4051 SERVICE MAINTENANCE INFORMATION

INTENT: Provide supplementary or additional maintenance information not available in the Service Implementation Plan or Service Manual. Reference should be made to the published Service Implementation Plan, dated August 21, 1981.

The 4051 CPU board (670-4008-06), 4051 standard backpack (670-4325-01), and 4051 communications backpack (670-7069-00) have all undergone changes. These changes do not affect the speed at which the 4051 does any of its operation.

Figure 1.

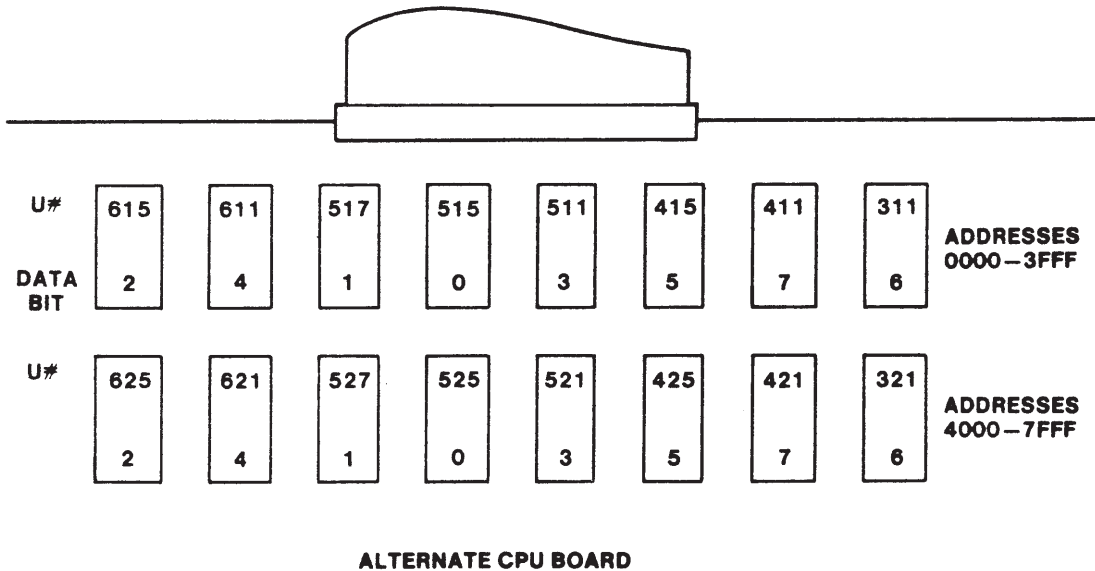
The RAMs that are being used will be 156-0968-02, which are 16Kx1 bit RAMs instead of the 156-0635-00 4Kx1 bit RAM. There will be only two RAM memory configurations for the new CPU boards. The two versions are the standard version which will be 16K bytes and the second will be the 32K bytes (Option 22). For use of the System Test Fixture the address breaks are in Figure 1.
